Technical Service Information

MERCEDES 722.3 /.4 BURNT FLUID (BELLVILLE PLATE INTERFACE)

1 - BELLVILLE WASHER
2 - RETAINING RING

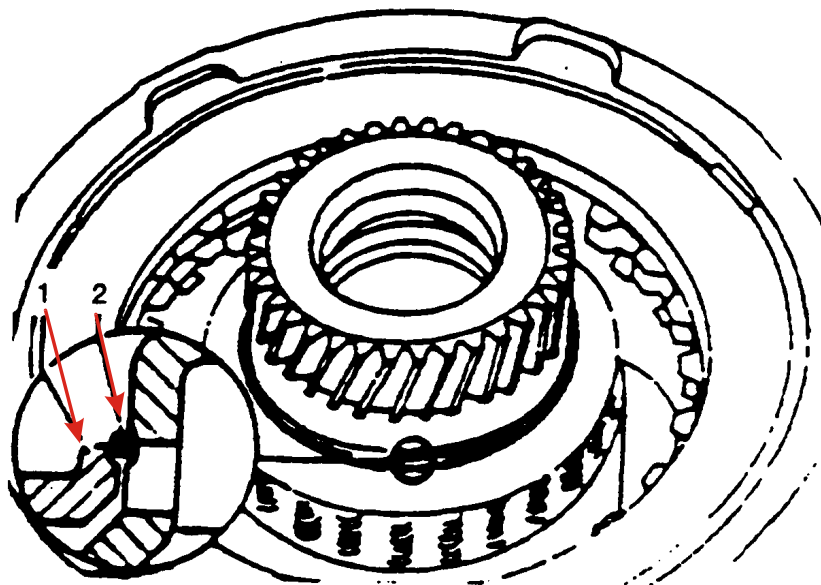
COMPLAINT: Transmission fluid is very dark or black, but does not smell burned. From 7/86 to 2/87 Production.

CAUSE: The bellville washer of the K-1 clutch rubs against the planetary-gear carrier of the front planetar

CORRECTION: Replace steel disks K-1, bellville washer, and retaining ring (Figure 1).

NOTE: If the transmission is disassembled for repairs, check to be sure the retaining ring sits properly in it's groove, or if the bellville washer already is pushed over the retaining ring. In this case, replace steel disks K-1, retaining ring, and bellville washer.
